## APPENDIX G

### **EIA Submission Errata**

Table 5.5 of the Mine Waste and Water Quality report

“General Site Plan” Figure in the Project Alternatives Report

FIGURE 3.1

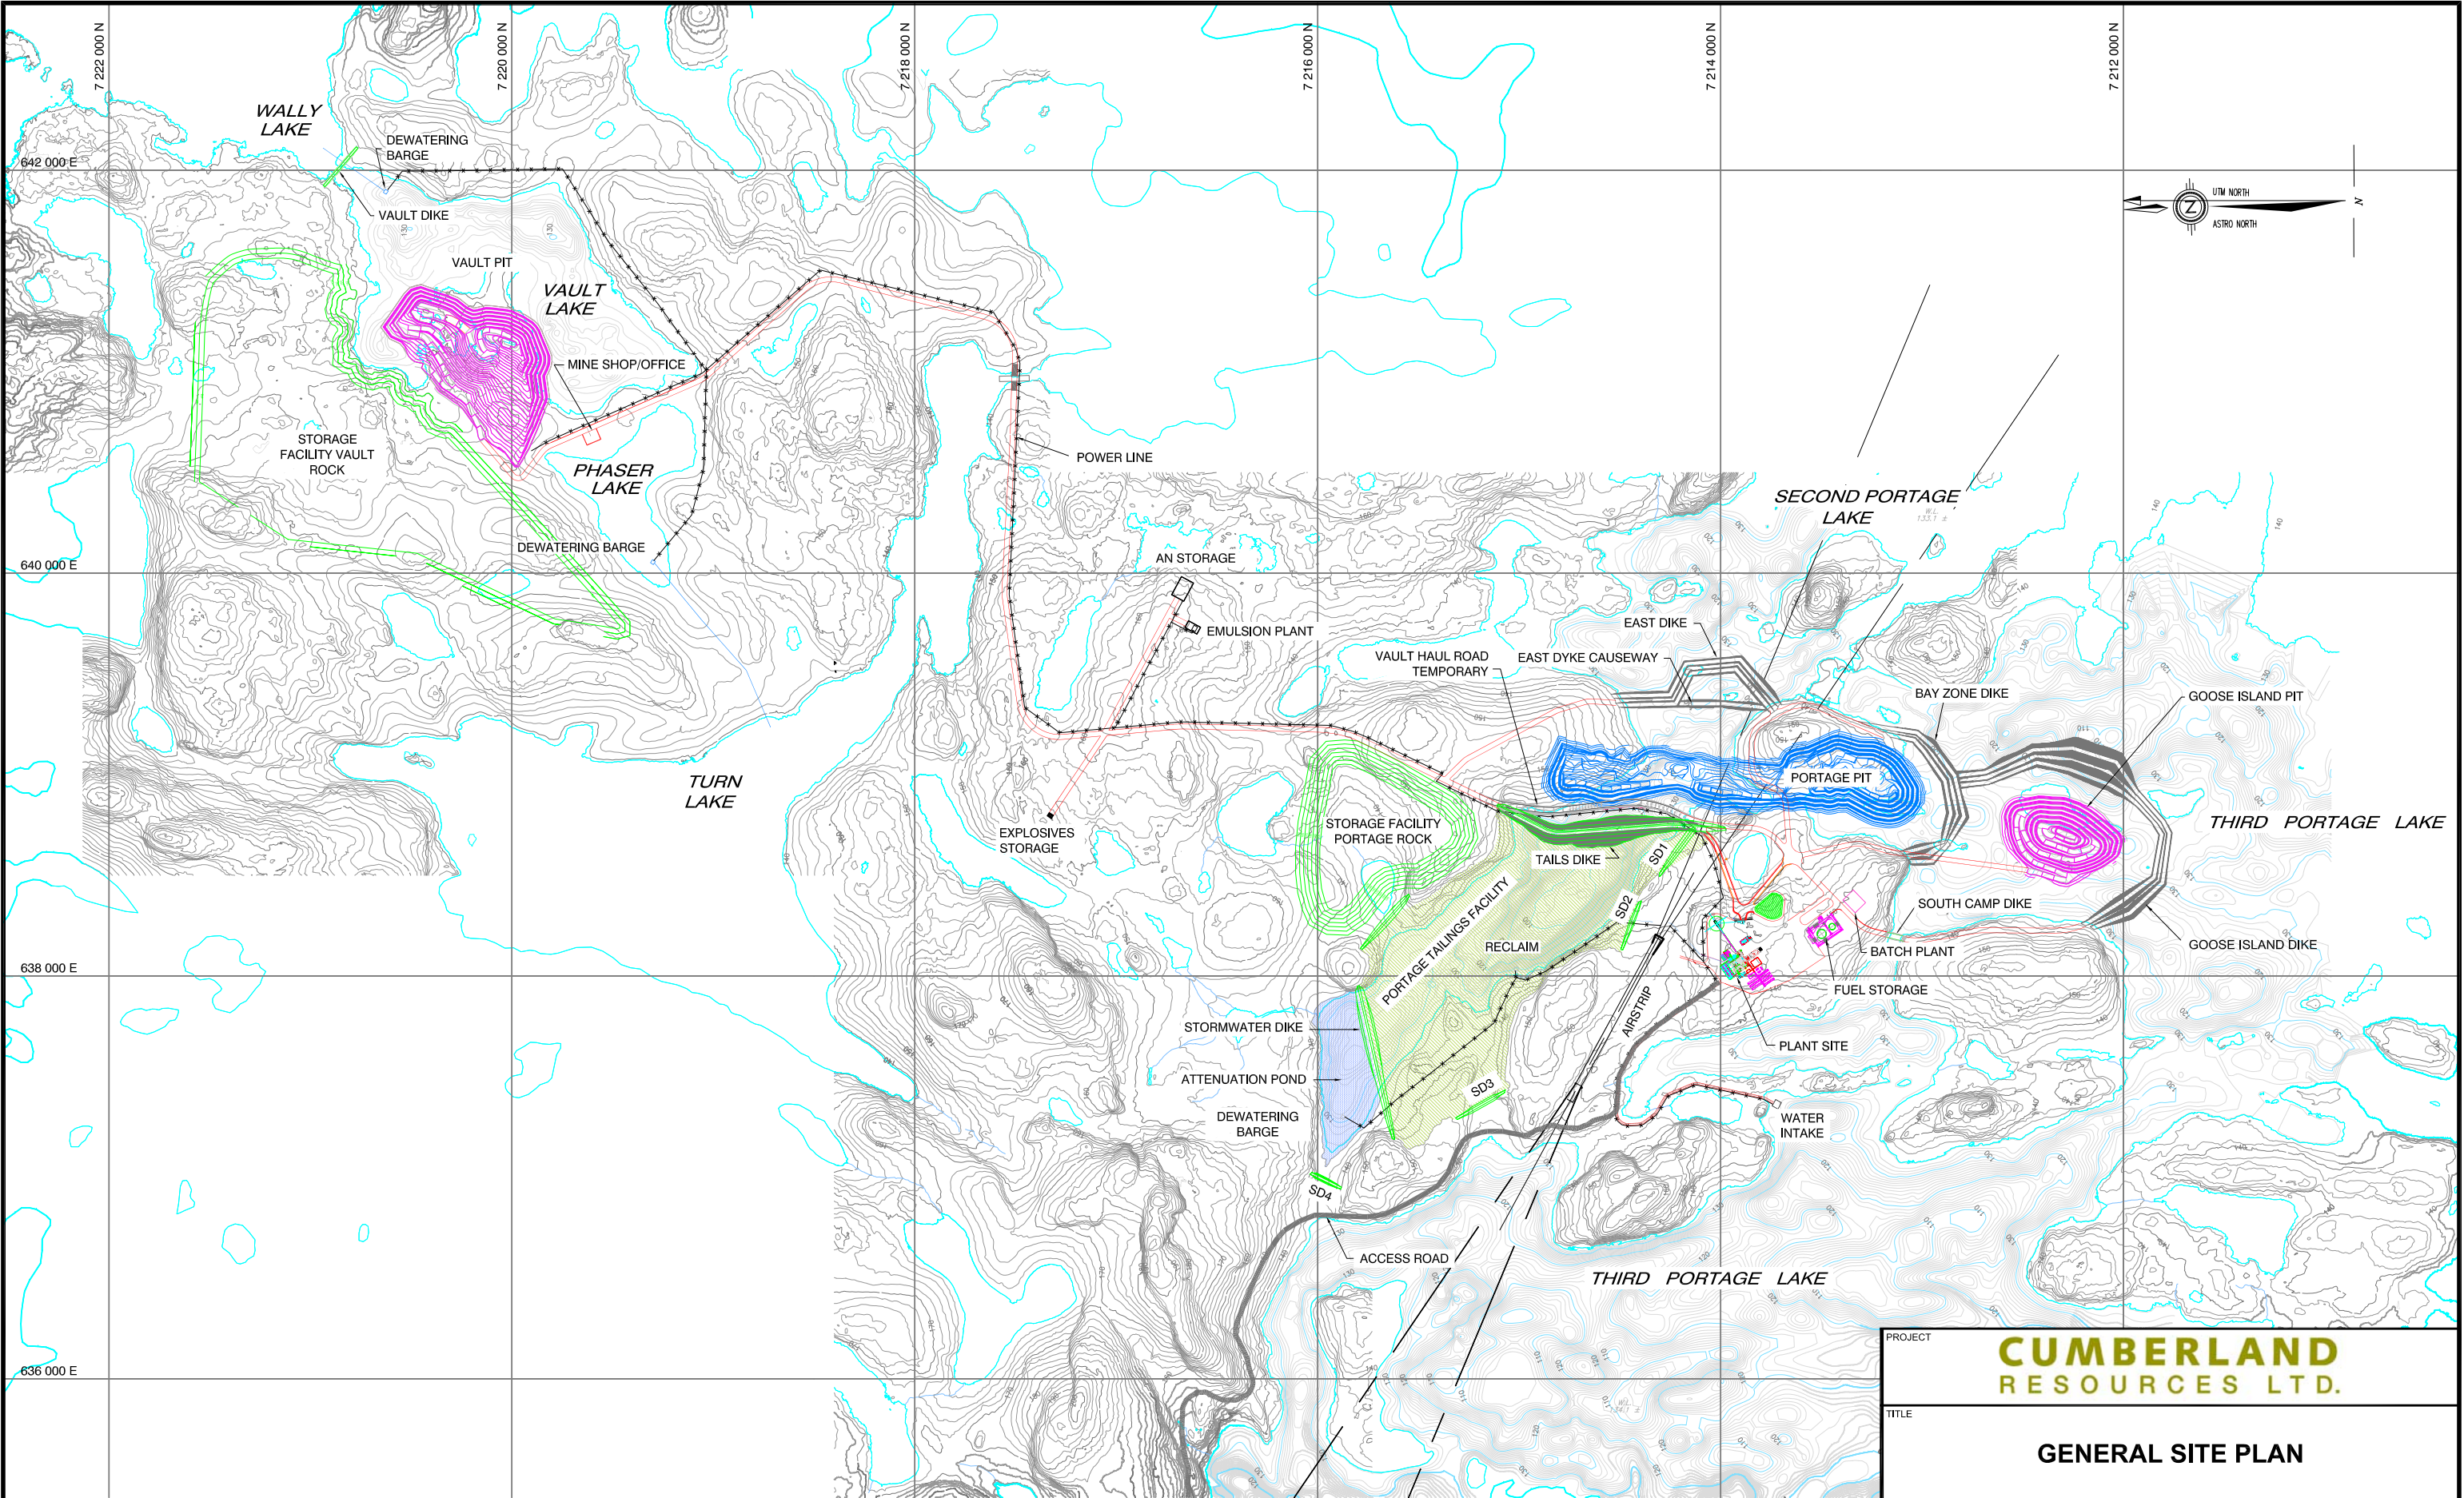
In the **Project Alternatives report**, the “**General Site Plan**” figure was distorted.

A replacement copy of this figure is provided on the following page.
